Subject: [EXTERNAL] Re: [EXTERNAL] Re: ROW Width highway 39

The owner has a subdivision application in right now and on the plat they are showing an 80' ROW. I just want to make sure that is what UDOT is expecting for the ROW width.

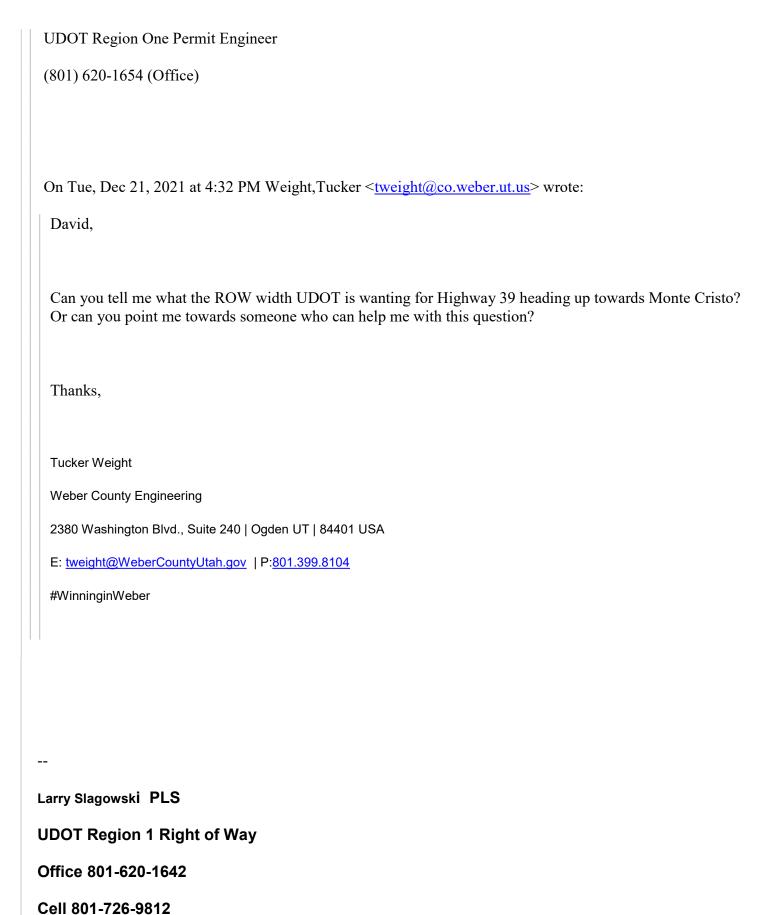
The area I am looking at is part of section 11, Township 6 North, Range 2 East.

The parcel number is 21-103-0007 and 21-013-0009.

I have attached highway plans that show Uodt has an 80' right of way width (40' each side of centerline) on US Hwy 39 in the area you have specified. So the representation of an 80' highway right of way width would be accurate as the plans show.

However, it appears that the eastern half of the two parcels you specified have some significant slope of which the toe of said slope lies near the edge of existing pavement. Therefore, for the preservation of future maintenance and/or expansion, it would be my preference that the developer either convey (by deed) an additional 10' width for future highway expansion or dedicate an additional 10' each side where relevant (50' half width total) for road purposes upon the subdivision plat as has been done upon the more recent (and adjacent) Mountain Prime Subdivision and Mountain Prime Subdivision 1st amendment plats.
